Docket Item # 3  
BAR CASE # 2011-0326

BAR Meeting  
January 4, 2012

**ISSUE:** Alterations to previously approved plans

**LOCATION:** 616 South Royal Street

Figure 1: Drawing showing 2003 approved and existing/proposed fence height.  
The background elevation drawing is from the 2008 alterations.

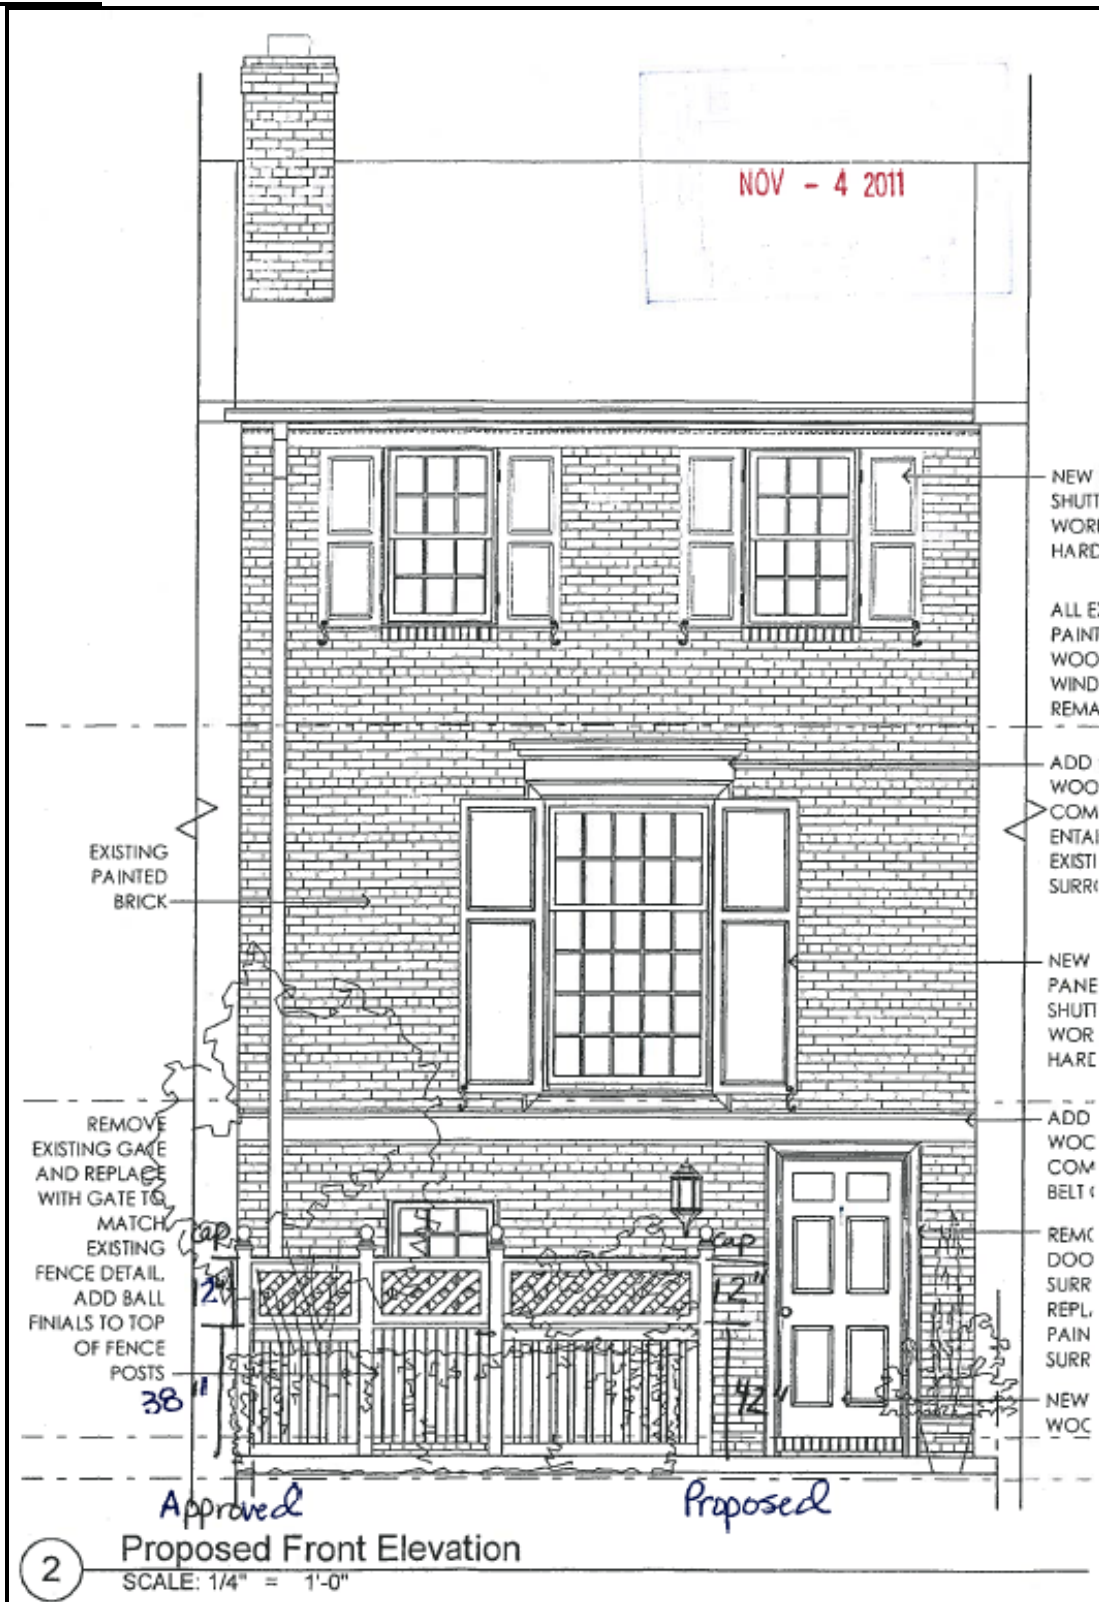
The applicant is requesting approval of an after-the-fact 4 inch height increase to a Board-approved 50 inch tall HVAC screen in the front yard at 616 South Royal Street. The HVAC enclosure measures approximately 11.5 feet wide by 54 inches high and is located to the north of the front door. No new construction is associated with the requested height increase, as the HVAC screening was constructed in 2003 at 54 inches and the discrepancy was only recently brought to Staff's attention.

As a result of a recent complaint, Staff and the applicant were made aware of a 4 inch height discrepancy between the Board approved enclosure (50 inches high) and what was actually installed by the contractor (54 inches high). The 2008 BAR approval for minor modifications to the screening did not include a request for the additional 4 inch height because, at that time, neither the applicant, nor Staff, realized that the fence was not in compliance with the prior approvals. The applicant surmises that the contractors installed a 42 inch high fence in compliance with the first approval, and subsequently installed a 12 inch lattice in compliance with the later 2003 approval.

Staff has no objection to increasing the height of the HVAC screening 4 inches above the previous BAR approval. The Board has approved the HVAC screening enclosure in this location on more than one occasion and the 4" additional height of the original screen, when constructed in 2003, was consistent with the original design intent. If the height increase had been obvious or inappropriate at that time, Staff and the Board would have noted the inconsistency during previous reviews.

Therefore, Staff recommends approval of the application as submitted.
